# Access Compliance Report

## Public Rights-of-Way

### (Curb Ramps)

Intersection ID: 10037286	Main Street: SARDIS_RD_NORTH	Cross Street: N/A	Location: N
ADA ID: 2E7CBC4E3D8E	Ramp Type: Para	Initial Pass/Fail: Fail	Overall Compliance: No
Codes/Mitigation Info/Possible Solution		Field Measurements/Component Compliance

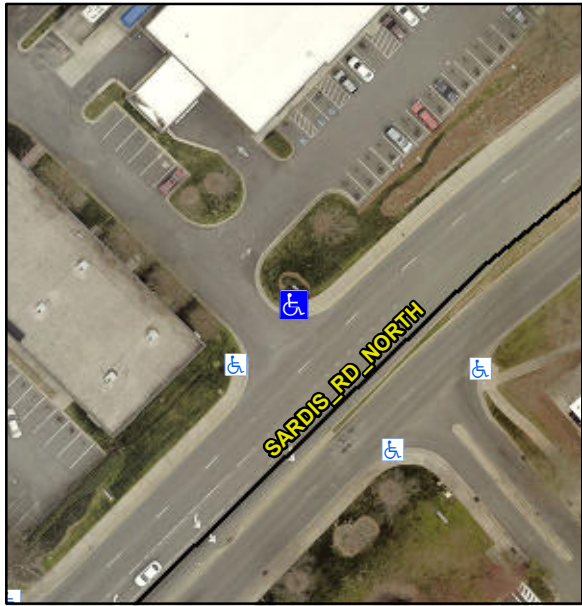
Remove & Replace Entire Ramp.

LT RP < 5%

R304.5.3, R304.3.2
